PATENT APPLICATION

Serial No.: 08/258,285 Group Art Unit: 2302

For: "ANTENNA CAP, ANTENNA CONNECTORS AND TELEPHONE
LINE CONNECTORS FOR COMPUTER DEVICES UTILIZING
RADIO AND MODEM CARDS"
(Attorney Docket No. 38000FB)

AMENDMENT

FIG. 2A

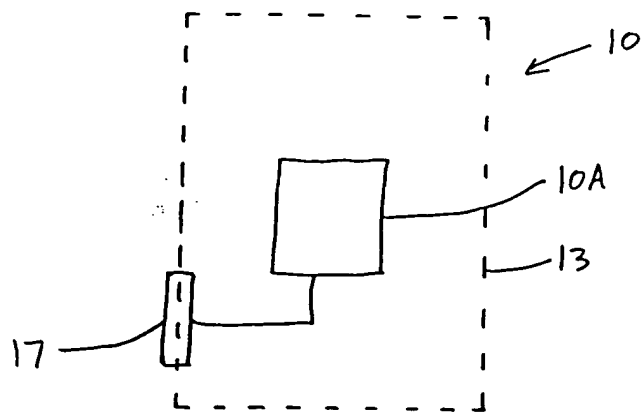
The Examiner has also objected to the drawings under 37 C.F.R. Sec. 1.83(a), indicating that the radio, cellular phone, and modem inside the card must be shown or the feature canceled from the claims. With this Amendment, Applicants submit new drawing figures 2A, 2B, and 2C, and accompanying description to illustrate the claimed features. Figure 2A illustrates a radio card (10) having a radio transceiver (10A) within its housing (13), electrically connected to an antenna contact block (17). This configuration is supported in the specification as filed at page 7 lines 10-21. Figure 2B illustrates a modem card (35) having a modem (35A) within its housing (36), electrically connected to a contact block (37). This configuration is supported in the specification as filed at page 8 lines 13-17. Figure 2C illustrates a modem card (35) having a modem (35A) and a cellular phone (38) within its housing (36), electrically connected to a contact block (39). This configuration is supported in the specification as filed at page 8 lines 13-17. Applicants therefore urge that new drawing figures 2A, 2B and 2C contain no new matter and show the claimed radio, cellular phone, and modem features, and respectfully request that the Examiner withdraw the objection to the drawings under 37 C.F.R. Sec. 1.83(a).

2. The drawings are objected to under 37 C.F.R. § 1.83(a). The drawings must show every feature of the invention specified in the claims. Therefore, the radio, cellular phone and modem inside card must be shown or the feature cancelled from the claim. No new matter should be entered.

--Fig. 2A is a block diagram of a radio card containing a radio transceiver in accordance with the present invention;

--Referring to Fig. 2A, a radio card (10) is shown in accordance with the present invention. The radio card (10) has a housing (13) and contains a radio transceiver (10A). The radio transceiver (10A) is electrically connected to an antenna contact block (17), which may for example be a pair of antenna contacts (15, Fig. 2). The radio card (10) may optionally have additional antenna contacts (see 20, Fig. 1) electrically connected to the radio transceiver (10A). The radio transceiver (10A) is not shown in Fig. 2A to scale, nor are the relative positions of the radio transceiver (10A) or the antenna contact block (17) on the radio card (10) drawn for accuracy; Fig. 2A is a block diagram intended only to show functional blocks of the radio card (10).

Fig. 27

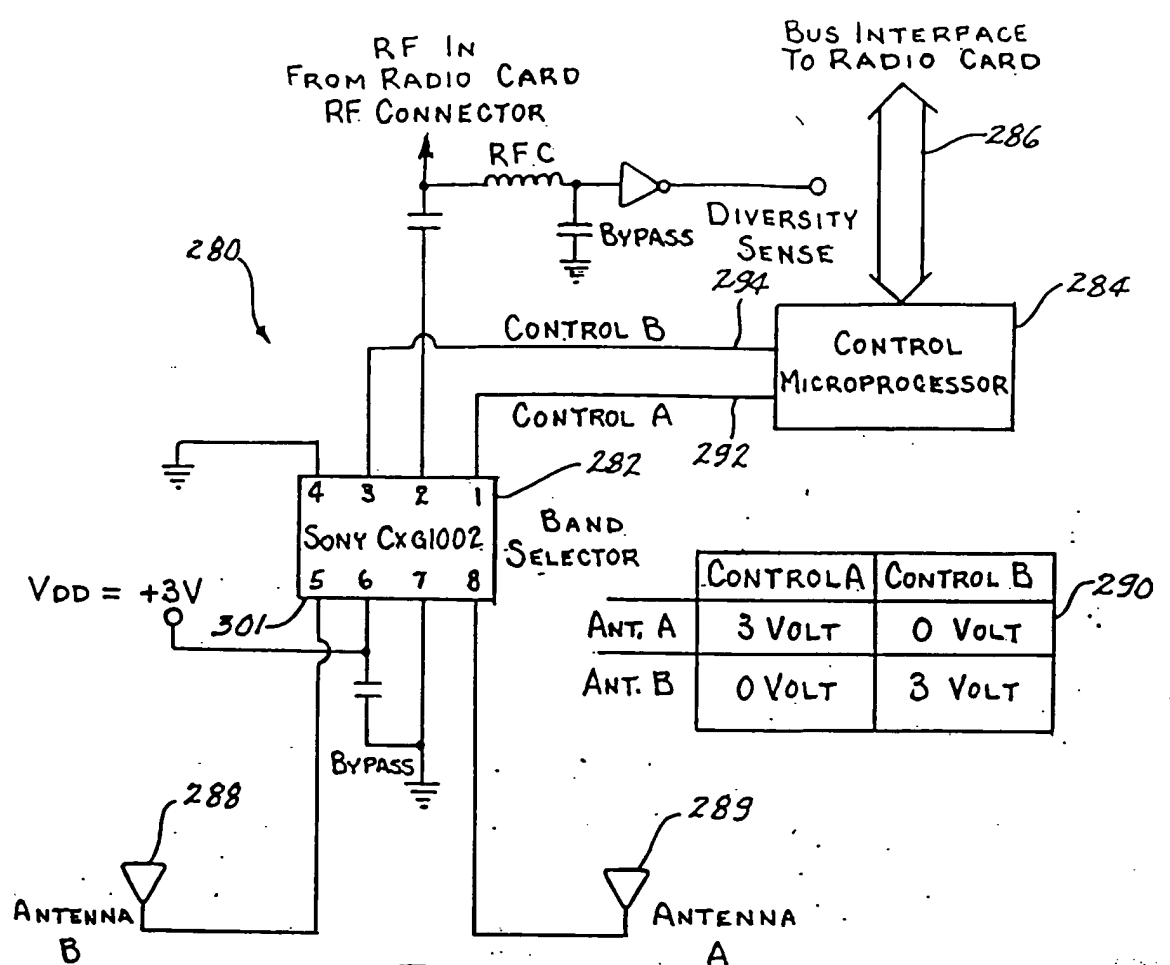
The Examiner has noted that the drawings for figures 27 and 28 do not correspond to the specification on pages 9 and 10. This irregularity is due to Applicants' inadvertent error in filing the application. With this Amendment, the correct drawings for figures 27 and 28 are being submitted. Applicants respectfully point out that these drawings for figures 27 and 28 are the same drawings present in previously filed Serial No. 08/226,256 (Docket No. 38000FA) filed April 11, 1994, and Serial No. 08/194,178 (Docket No. 38000F) filed February 9, 1994, from which priority is claimed in the instant application under 35 U.S.C. Sec. 120. Additionally, the description of figures 27 and 28 in the instant application is identical to the description of those figures in Serial No. 08/226,256 [see p. 10 line 3 - p. 11 line 4] and in Serial No. 08/194,178 [see p. 12 line 5 - p. 13 line 26], and this description clearly applies to the corrected figures 27 and 28 rather than figures 27 and 28 as originally (and inadvertently) filed in the instant application. Applicants therefore urge that

1. The drawings are objected to because of informalities stated on PTO-948 form. The drawings for figure 27 and 28 do not correspond to the specification on pages 9 and 10. Correction is required.

the corrected figures 27 and 28 present no new matter, and their entry in the instant application is respectfully requested.
